Western Harbour Tunnel and Warringah Freeway Upgrade

Appendix E –
Groundwater memorandum

Subject	Environmental Impact Statement; Groundwater assessment	Project Name	Western Harbour Tunnel and Warringah Freeway Upgrade
Attention	Jamie Crawford (Arcadis)	Project No.	IA146500
From	Pride Mangeya and Ben Rotter (Jacobs)		
Date	28 August 2020

This memorandum provides a response to issues raised by the NSW Environment Protection Authority and the Department of Planning, Industry and Environment (Water) and the Natural Resources Access Regulator in relation to Appendix N (Technical working paper: Groundwater) of the environmental impact statement (EIS).

Figure 2.1 Groundwater and surface water monitoring sites (updated Figure 4-2 of Appendix N (Technical working paper: Groundwater))

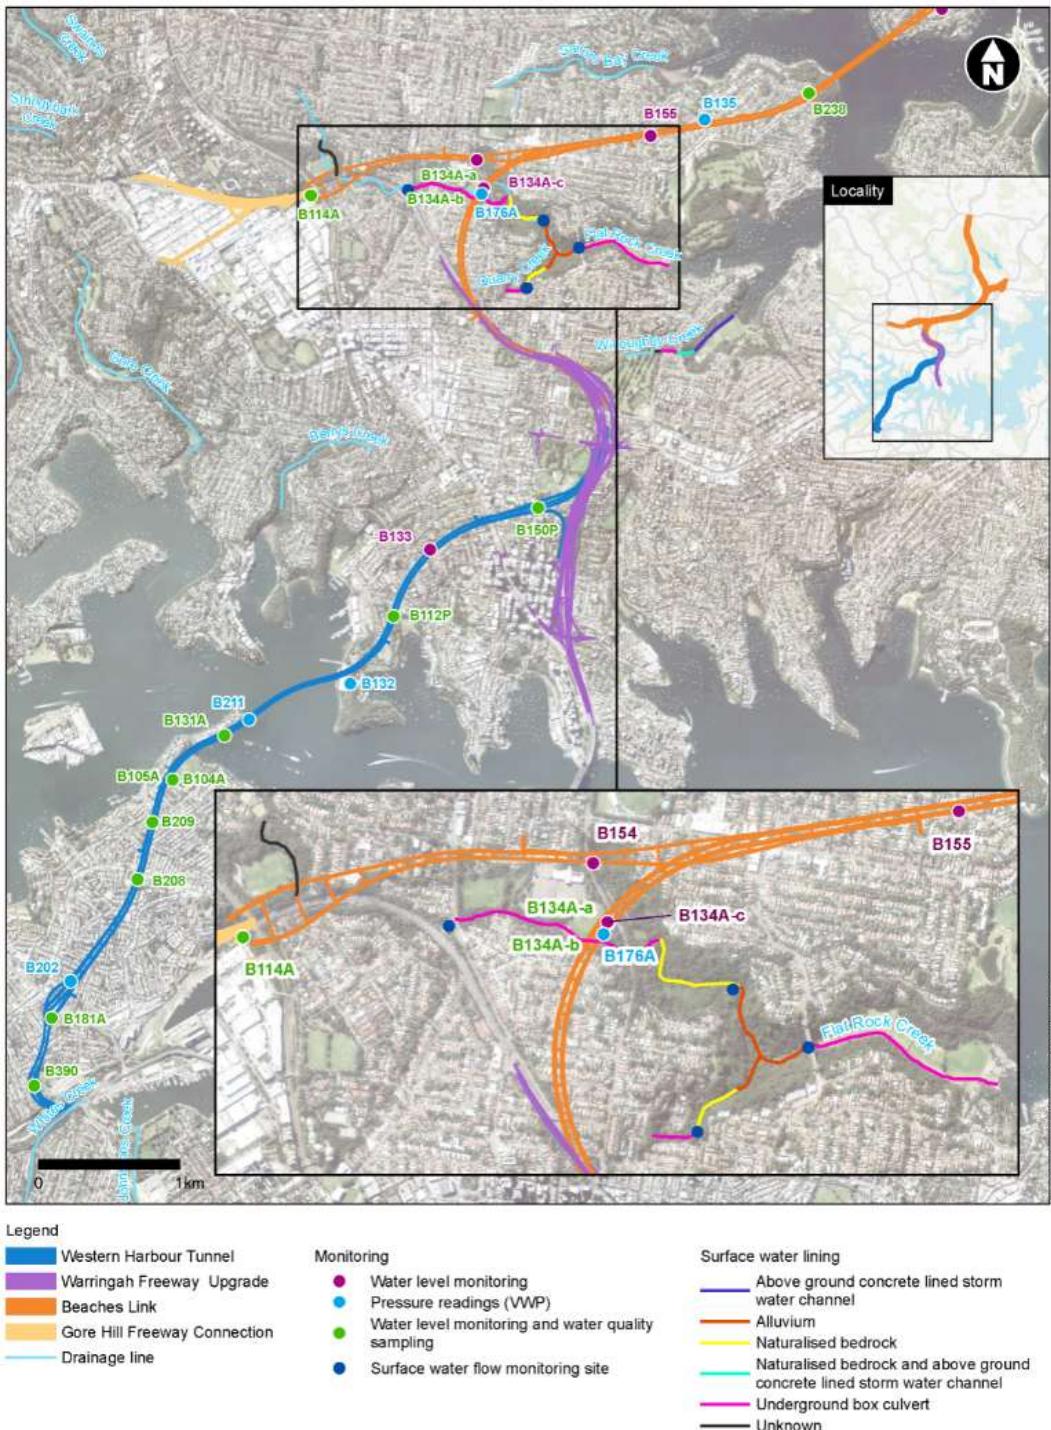
Table 5-10 and Figure 4-2 in Appendix N (Groundwater) of the EIS identify eight groundwater monitoring bores near the proposed infrastructure alignment have been used to sample groundwater quality since November 2017. However, these results differ from those shown in Appendix D of Appendix N, which provides the full analytical results (monthly samples) in that:

- Monitoring has not been done at regular intervals*
- Maximum of six sampling rounds were conducted since the bores were constructed in November 2017.*

The locations of the monitoring piezometers are shown in Figure 2.1. Figure 2.1 is an updated version of Figure 4-2 contained in Appendix N (Technical working paper: Groundwater), showing the additional monitoring location at piezometer B209, and reflecting the fact that water quality sampling has been carried out at piezometers B112P, B150P and B208.

Results for piezometer B209 were not previously available, as access to monitor at this location had not been granted.

Piezometers B112P and B150P are monitoring locations that were installed subsequent to initial locations. These additional piezometers were reportedly installed (immediately adjacent to existing piezometers) due to issues with groundwater quality at the existing piezometers B112 and B150.

Figure 4.1 Hydraulic conductivity versus depth at bores along tunnel alignment.

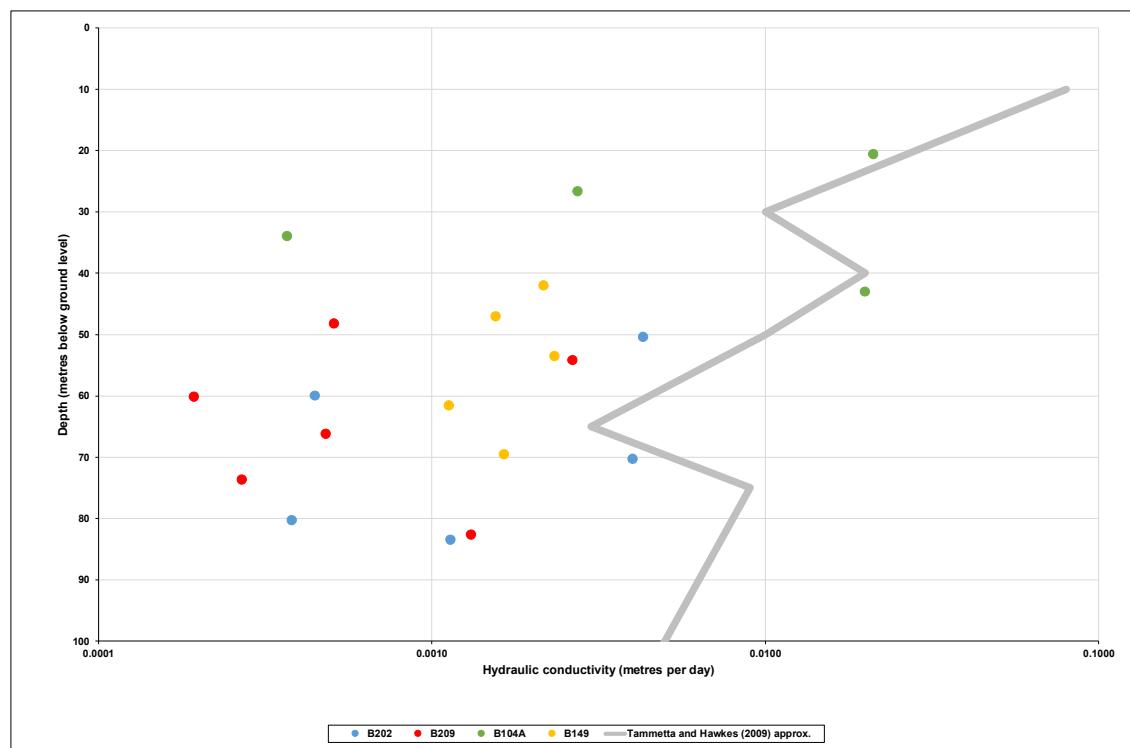
Provide DPIE-Water schematic of the hydrogeological conceptual model for:

** These must include the geology units, known geological structures, proposed Western Harbour tunnel alignment, relevant monitoring bores and their relative depths, with groundwater levels.*

Project-specific geotechnical investigations including packer testing (hydraulic testing) were carried out at bores to estimate hydraulic conductivity. Figure 4.1, is a revised version of Figure 2-9 in Appendix F of Appendix N (Technical working paper: Groundwater). Figure 4.1 shows the results of packer test

estimates for Hawkesbury Sandstone hydraulic conductivity plotted against depth below ground level at four bores along the project alignment south of Sydney Harbour between Rozelle and Birchgrove (B202, B209, B104A, B149). For comparison, Figure 4.1 also shows the geometric mean of hydraulic conductivity values obtained from packer tests carried out at bores in the Hawkesbury Sandstone across the Sydney Basin by Tammetta and Hawkes (2009)¹.

Data from the regional analysis (Tammetta and Hawkes, 2009) indicates a clear trend of decreasing hydraulic conductivity with depth below ground level. Results presented in Figure 4.1 for four bores along the project alignment between Rozelle and Birchgrove (B202, B209, B104A, B149) are highly variable but do indicate an upper limit to hydraulic conductivity that decreases with depth.

The estimated hydraulic conductivity values at bores along the project alignment between Rozelle and Birchgrove show some consistency with the regional assessment by Tammetta and Hawkes (2009), although the values are generally below the regional average.

Figure B1 - Map showing location of section lines

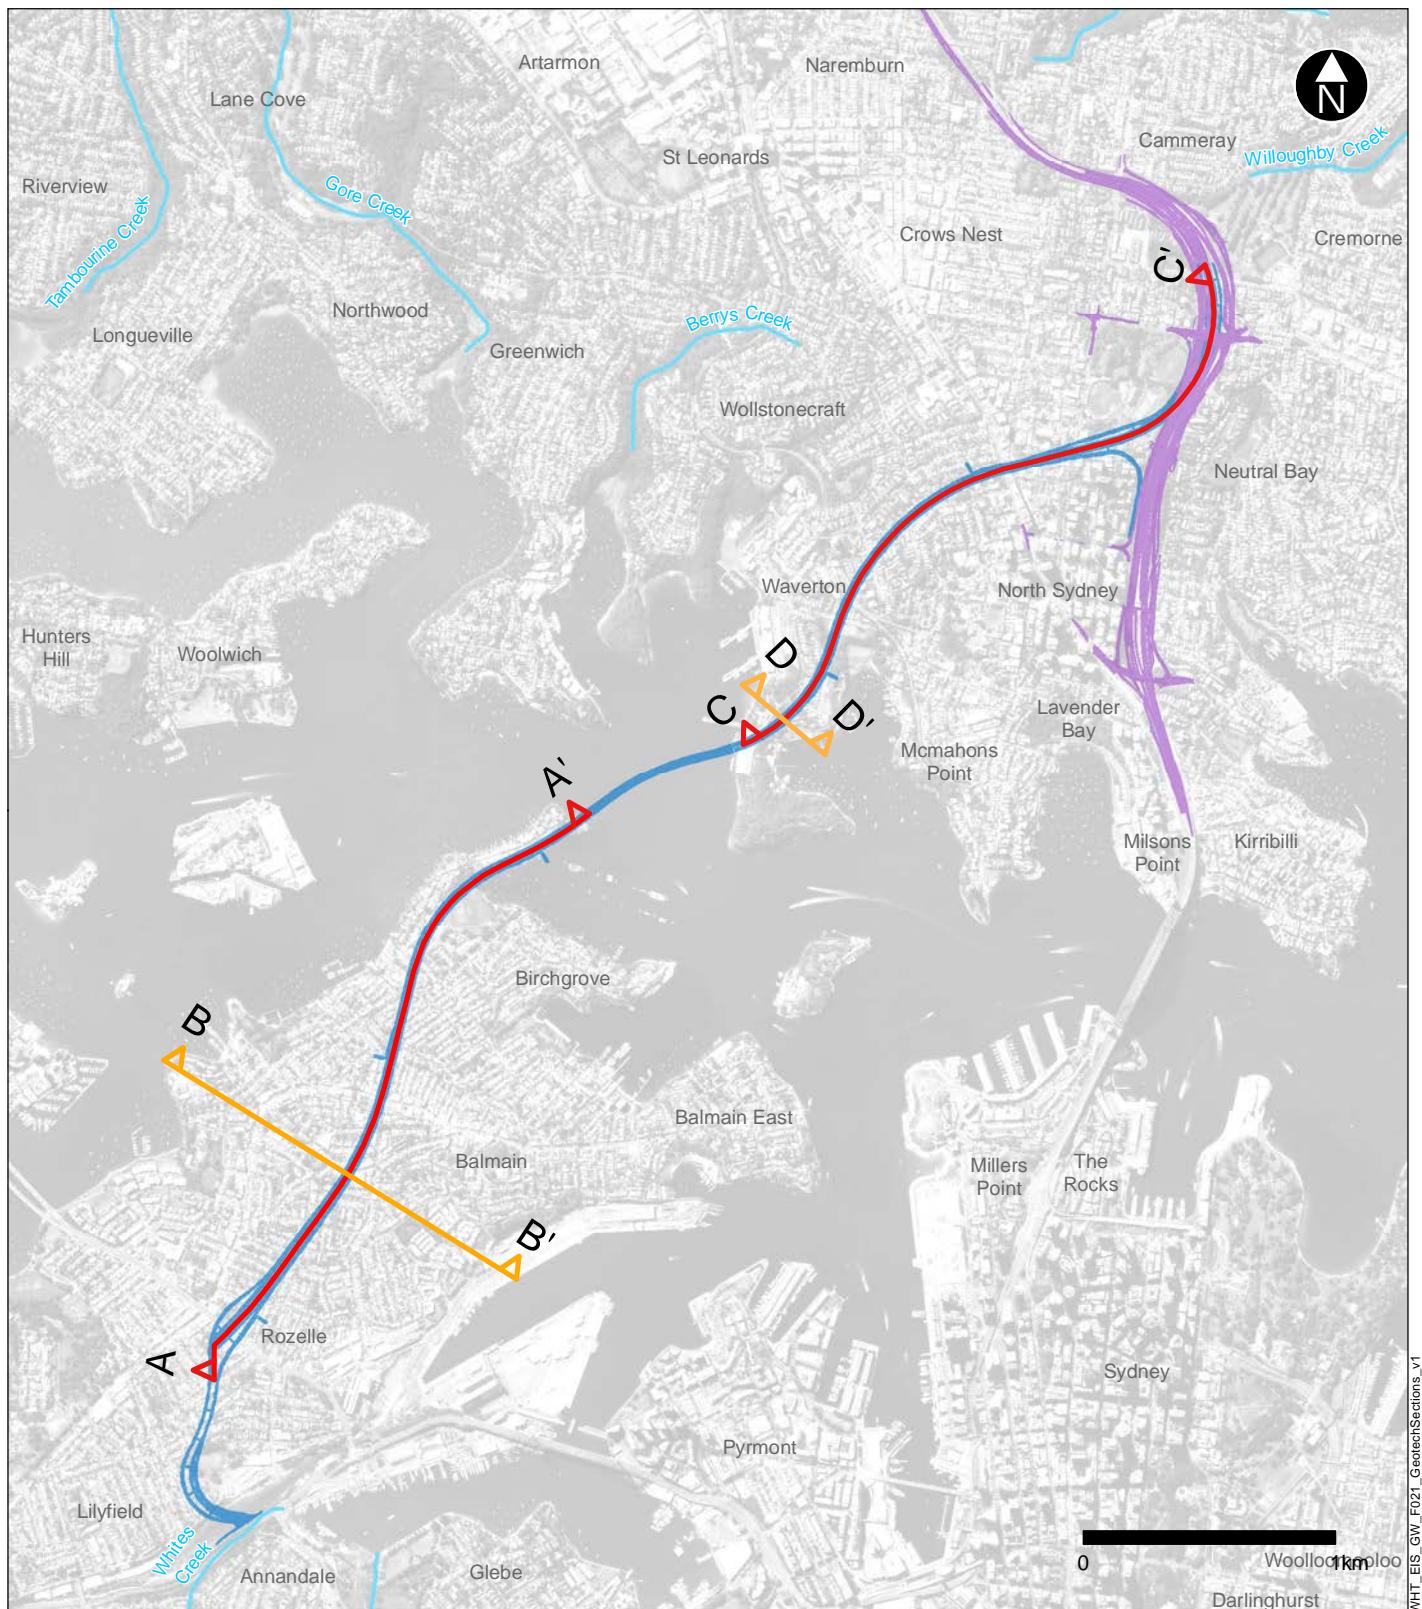
** The Western Harbour Tunnel; Rozelle to Birchgrove and Balls Head to Warringah Freeway sections*

Schematics of the conceptual hydrogeological model are presented in Attachment B of this memorandum. Figures provided in Attachment B are as follows:

- Figure B1 – Map showing location of hydrogeological section lines
- Figure B2 – Hydrogeological section along line A-A'
- Figure B3 – Hydrogeological section along line B-B'
- Figure B4 – Hydrogeological section along line C-C'
- Figure B5 – Hydrogeological section along line D-D'.
